# DEVELOPMENT REVIEW BOARD REPORT

SUBJECT	<b>Cantabrica Preliminary Plat</b>
REQUEST	<p>Request preliminary plat approval for 9 residential lots with amended development standards on a 28.5+/- acre parcel.</p> <p><b>15-PP-2004</b></p> <p><b>Key Items for Consideration:</b></p> <ul style="list-style-type: none"><li>• The applicant requests to establish estate lots under the current site zoning.</li><li>• Amended development standards are requested.</li><li>• No public opposition has been received with this case.</li></ul>
OWNER	Vincent DeAcitis
APPLICANT CONTACT	David Shapiro Mcguire Construction Corp 602-650-1608
LOCATION	11885 E Jomax Road, southeast corner of Jomax Rd. and 118 <sup>th</sup> St.
BACKGROUND	<p><b>Zoning.</b></p> <p>The site is zoned R1-130 ESL (Residential) District. This zoning district allows for single-family residential and associated uses on lots of 3 acres or more. The ESL overlay provides for maintenance of a portion of the property as natural desert and provides for amended development standards.</p> <p><b>Context.</b></p> <p>This subdivision is located in the Goldie Brown Estates area of the City. The surrounding property is zoned R1-130 ESL. The Yearling

# PRELIMINARY PLAT - NAOS EXHIBIT CANTABRICA

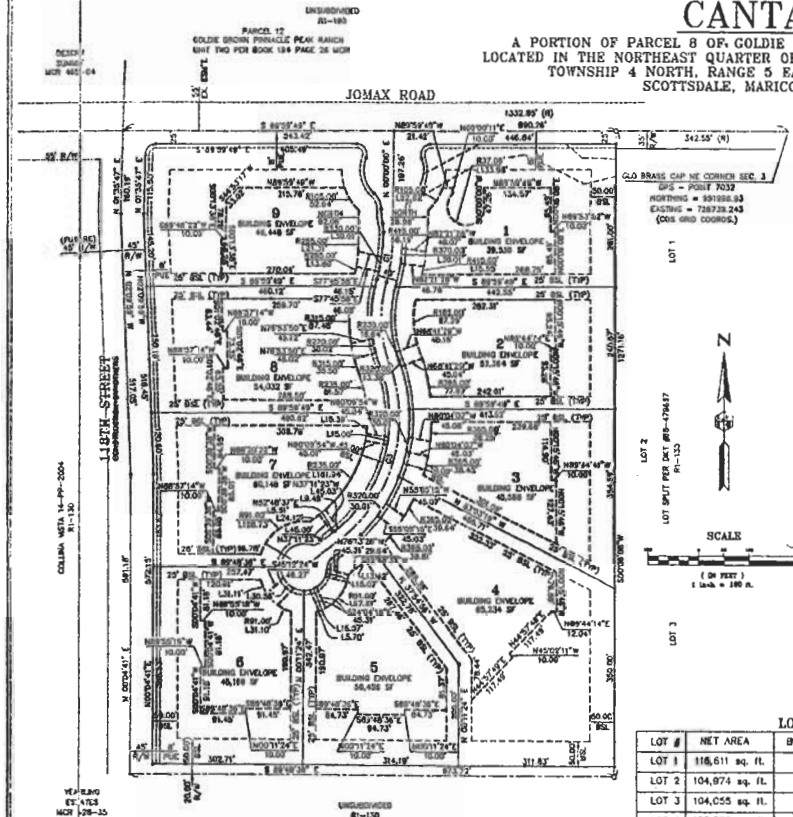
23. All areas of NAOS shown on NAOS exhibit, excluding those areas within the current 55' roadway easement on northern site boundary, shall be dedicated with final plat. Areas of NAOS currently within boundaries of 55' roadway easement on Lots 1 and 9 shall be dedicated at time of those lot's development. The amount of NAOS to be dedicated by Lot 1 at time of development shall be approximately 8,197 square feet. The amount of NAOS to be dedicated by Lot 9 at time of development shall be approximately 8,922 square feet.
